DART AEROSPACE LTD		Work Order:	147837
Description: Crosstube Assembly		Part Number:	D407-667-145
Inspection Dwg: D407-667-145 Rev: C		Page 1 of 2

DART AEROSPACE LTD HAWKESBURY, ONTARIO, CANADA	
DRAWING NO. D407-667-145	REV. C SHEET 1 OF 4
TITLE CROSSTUBE ASS'Y (407 HIGH FWD)	SCALE NTS
COPYRIGHT © 2002 BY DART AEROSPACE LTD THIS DOCUMENT IS PRIVATE AND CONFIDENTIAL AND IS SUPPLIED ON THE EXPRESS CONDITION THAT IT IS NOT TO BE USED FOR ANY PURPOSE OR COPIED OR REPRODUCED IN ANY MANNER WITHOUT WRITTEN PERMISSION FROM DART AEROSPACE LTD.

DRAWING NO. D407-667-145	TITLE CROSSTUBE ASS'Y (407 HIGH FWD)	REV. C	DART AEROSPACE LTD ENGINEERING ORDER		D.E.O. NO. D407-667-145-C-1	SHEET NO. SHEET 1 OF 1	SCALE NTS
DRAWN 9	CHECKED ASS	MFG. APPR. 188	APPROVED MD		DE APPR. H		
DATE 11.07.15	DATE 11.07.22	DATE 11.07.22	DATE 11/07/22		DATE 11.07.21

DRAWING NO. D407-667-145	TITLE CROSSTUBE ASS'Y (407 HIGH FWD)	REV. C	DART AEROSPACE LTD ENGINEERING ORDER	D.E.O. NO. D407-667-145-C-2	SHEET NO. SHEET 1 OF 1	SCALE NTS
DRAWN AJS	CHECKED <i>[Signature]</i>	MFG. APPR. <i>[Signature]</i>	APPROVED <i>[Signature]</i>	DE APPR. <i>[Signature]</i>		
DATE 12.08.02	DATE 12.08.02	DATE 12.08.02	DATE 12.08.02	DATE 12.

DETAIL P
 BONDING STRAP INSTALLATION 2 PL

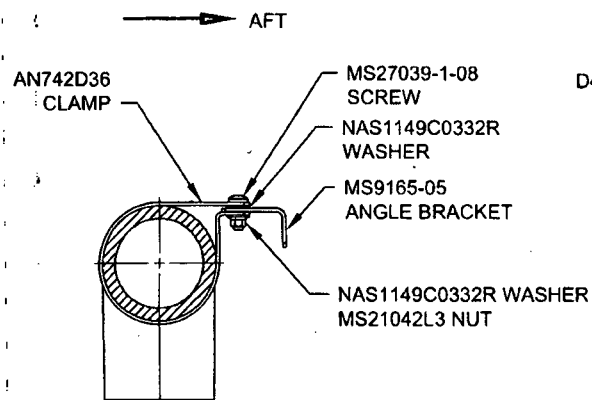
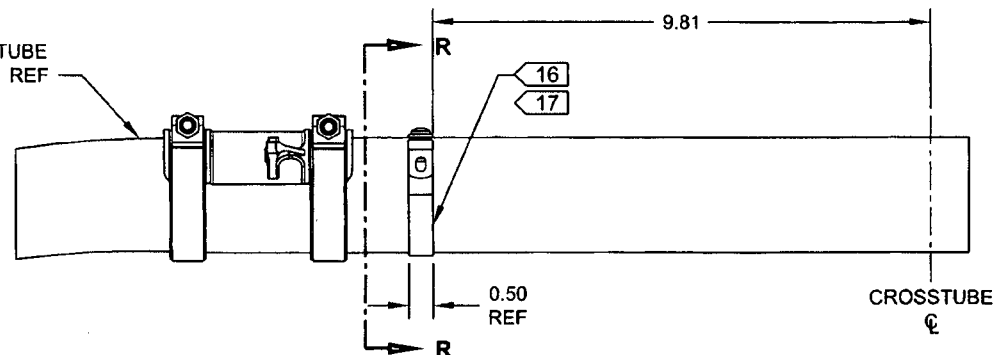
ADD ELECTRICAL GROUNDING STRAP

ITEM	QTY -145	PART NUMBER	DESCRIPTION
1	X	D407-667-145	CROSSTUBE ASSEMBLY (407 HIGH FWD)
10	2	AN742D36	CLAMP
11	2	MS9165-05	ANGLE BRACKET
12	2	MS21042L3	NUT (OR MS21042-3)
13	2	MS27039-1-08	SCREW
14	4	NAS1149C0332R	WASHER (OR AN960C10L)

- 16) MASK AREA UNDER CLAMP PRIOR TO PAINTING
- 17) SEAL EDGES WHERE AN742D36 CLAMP MEETS WITH THE CROSSTUBE USING SIKAFLEX-241/291 OR MIL-S-8802 CLASS B2 OR PROSEAL 890 SEALANT
- 18) PERFORM RESISTANCE CHECK TO ENSURE MAX RESISTANCE IS 10 MILLIOHMS
